Product Bulletin # TDS-218 Rev 3

Back-up Wrench Gripper Unintended Movement

Canrig top drives models C500 & C750.

Figure 2: Schematic for the BUW after removing the pressure reducing valve with check valve

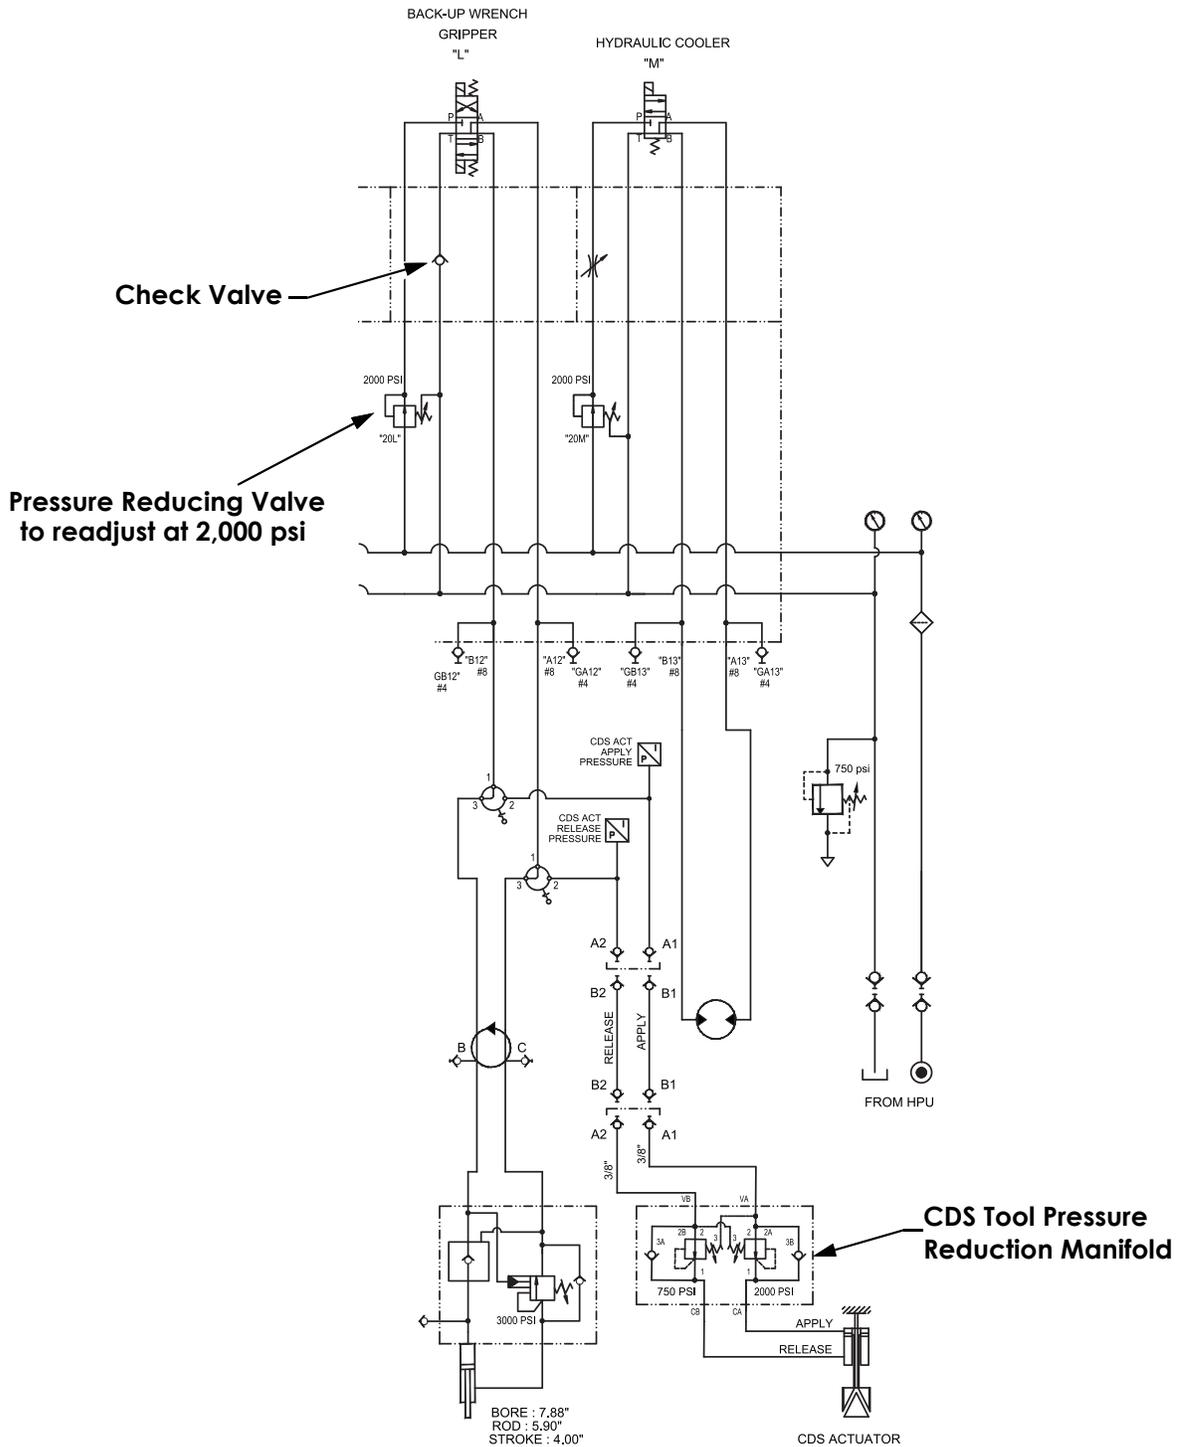
- To prevent this situation, remove the pressure reducing valve on station "L" (BUW gripper) of the top drive hydraulic manifold and install the check valve. Contact RIGLINE 24/7™ to order the kit (Canrig P/N: AY25154) and refer to section below "Check Valve Installation" on page 5. See Figure 2 on page 3 for schematic included with check valve stack attached to top drive hydraulic manifold.

Figure 3: Schematic for the BUW after removing the pressure reducing valve without check valve

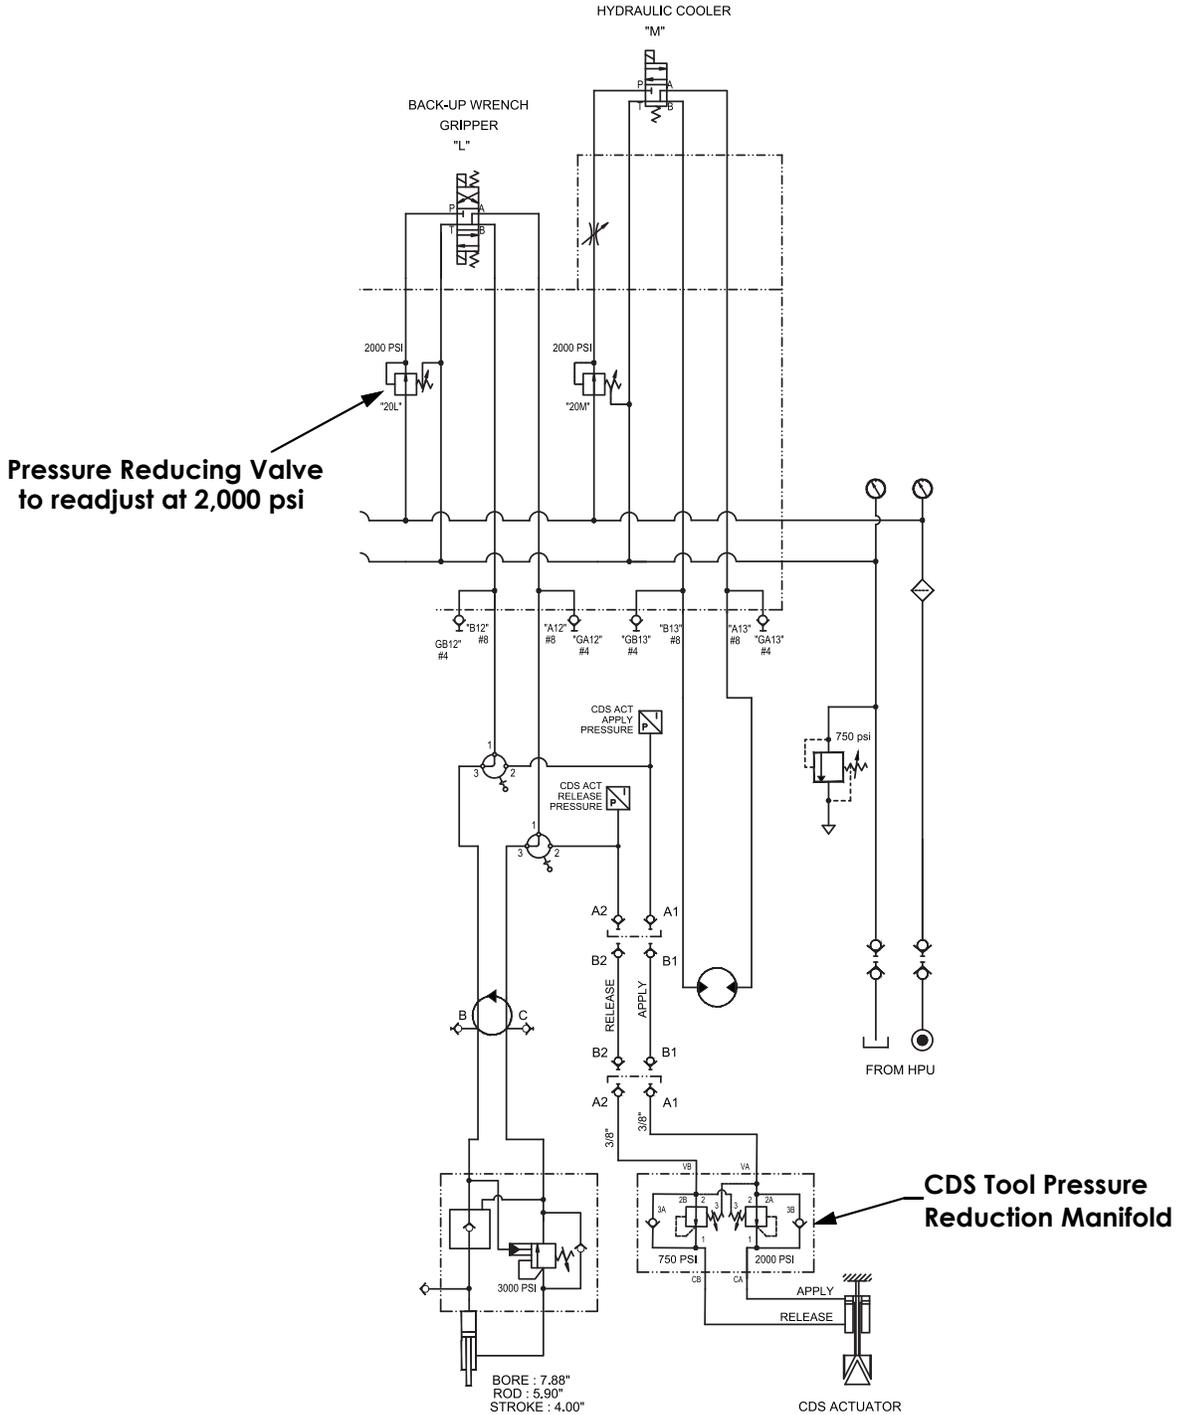
- If the kit (Canrig P/N: AY25154) is not being implemented per above, Canrig strongly recommends to remove the pressure reducing sandwich valve and install the BUW solenoid valve (DCV) back on manifold using socket head fasteners (Canrig P/N: SH-10-24-0200). See Figure 3 on page 4 for schematic.

- After removing the 750 psi pressure reducing sandwich valve, ensure the pressure reducing valve cartridge located at the 20L port on the hydraulic manifold is set to 2,000 psi.

Figure 4: Hydraulic manifold

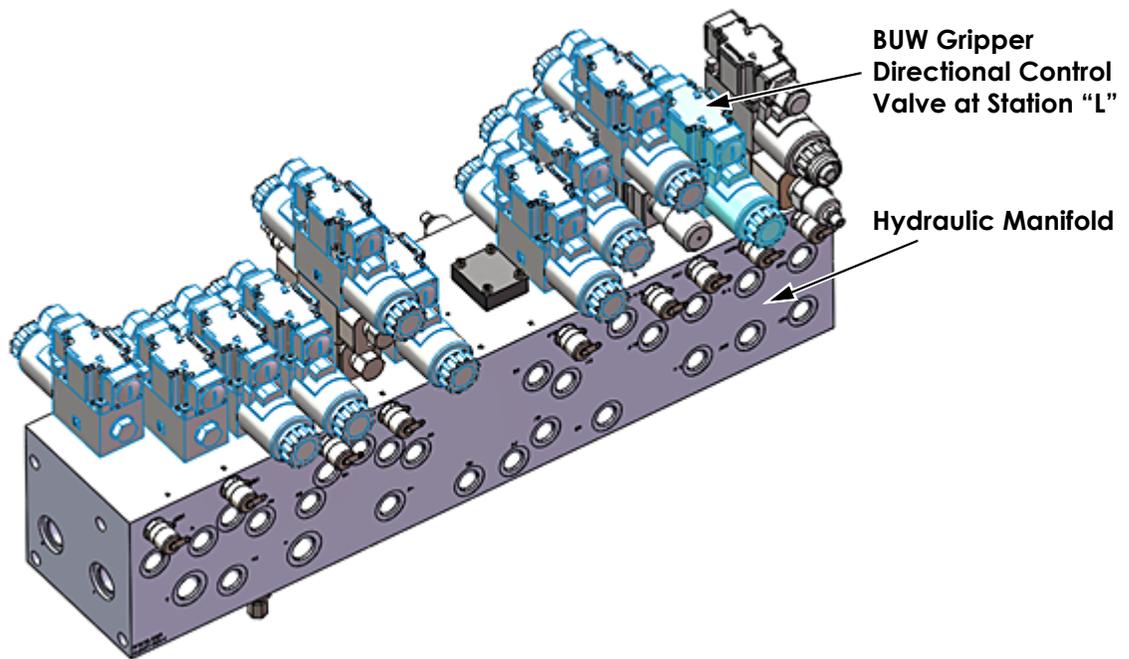
1. See Figure 4 to locate the BUW gripper valve bank (station L) on the top drive hydraulic manifold.

Figure 5: Pressure reducing valve

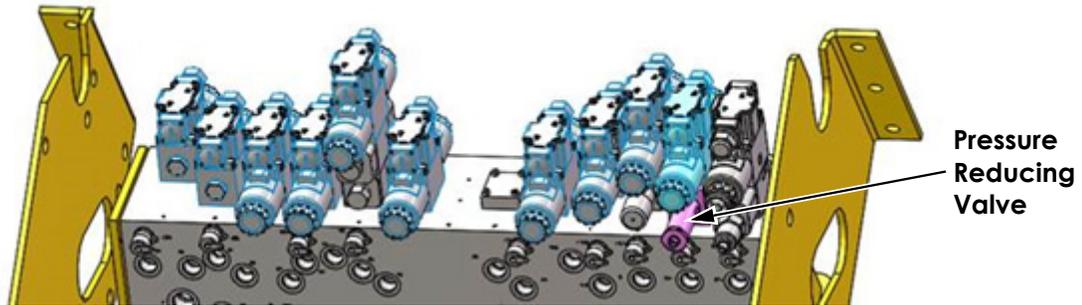
- Unscrew the fasteners to remove the pressure reducing valve (PRV) as shown in Figure 5. If the check valve is not available then install the BUW valve bank using the socket head fasteners (Carrig P/N: SH-10-24-0200).

Figure 6: Installing check valve

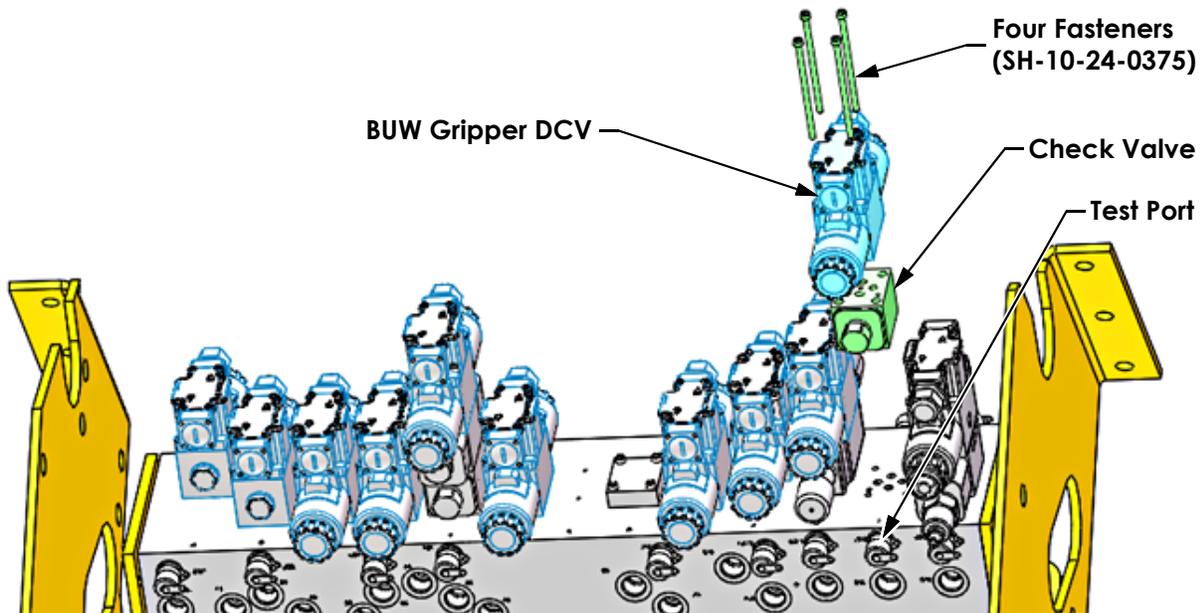
- Using the fasteners from the kit, install the check valve assembly (P/N: H07-1010-030) between the BUW gripper DCV and the hydraulic manifold as shown in Figure 6. Torque the fasteners to 6.5 ft-lbs using Loctite[®] 242.

Check valve knob must be oriented toward the hydraulic manifold test port as shown in Figure 6.
